MILITARY SPECIFICATION

WARHEAD, GUIDED MISSILE, HE, M207E2
LINER FOR

This Amendment forms a part of Military Specification MIL-W-63451 (AR) dated 17 June 1981 and is approved for use by the U.S. Army Armament, Munitions and Chemical Command and is available for use by all Departments and Agencies of the Department of Defense.

FIGURE 1

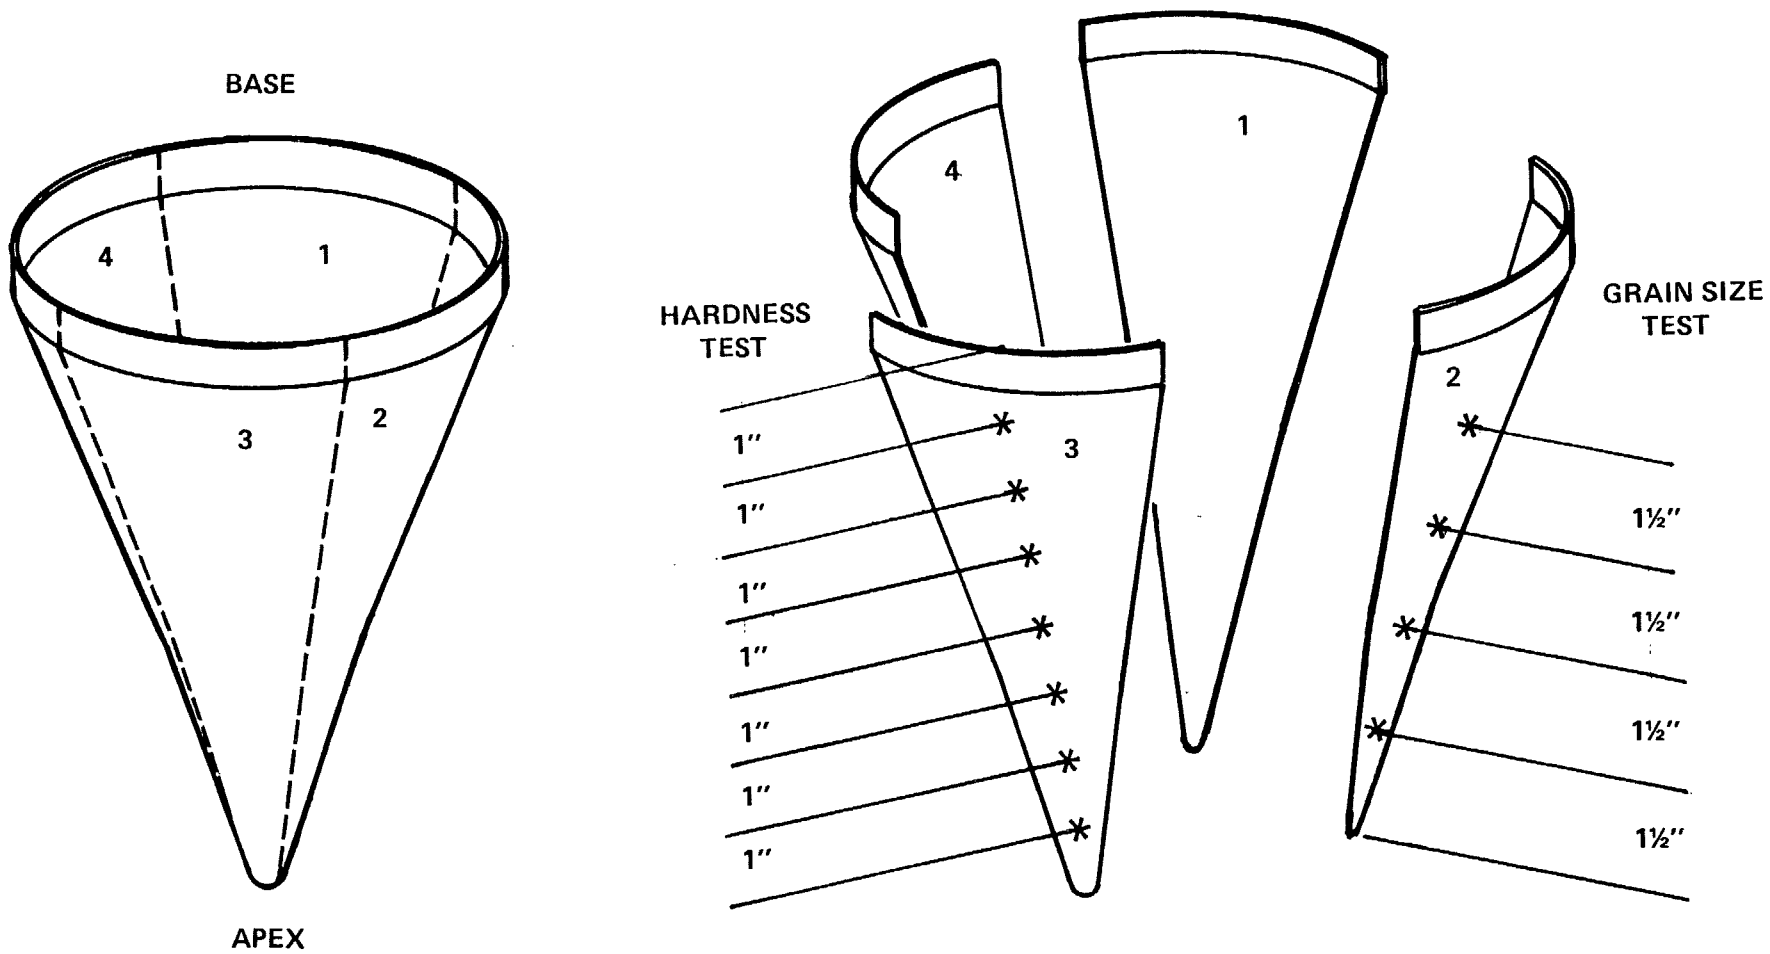
4.5.2.4 Hardness of finished liner. The sample liners shall be sectioned longitudinally into four equal parts and marked for exact location relative to the finished liner. The Rockwell F hardness readings shall be taken one-inch from the base and every one inch thereafter in a longitudinal direction, from base to apex, for seven readings on each section. (See Fig. 1). A total of twenty-eight readings shall be taken for the finished liners. The hardness readings shall be identified as to their location on the liner. The recorded readings shall be analyzed for variations in hardness in both the longitudinal and circumferential directions. If any of the sample liners do not meet the hardness requirement specified on the drawing, the liner heat treat batch represented by the samples shall be rejected. The hardness test data shall be submitted in accordance with DI-T-5247 (Tailored) (See 6.4). This is a destructive test.

4.5.2.5 Grain size of finished liner. A test section from 4.5.2.4 shall be utilized for taking grain size. Grain size shall be taken on one of the quartered sections in a longitudinal direction 1 1/2-inch from the apex and 1 1/2-inch apart from each other for a total of four readings per sample liner. (See Fig. 1). If any of the sample liners do not meet the grain size requirements as specified on the drawing, the liner heat treat batch represented by the sample shall be rejected. The grain size test data shall be submitted in accordance with DI-T-5247 (Tailored) (See 6.4)."
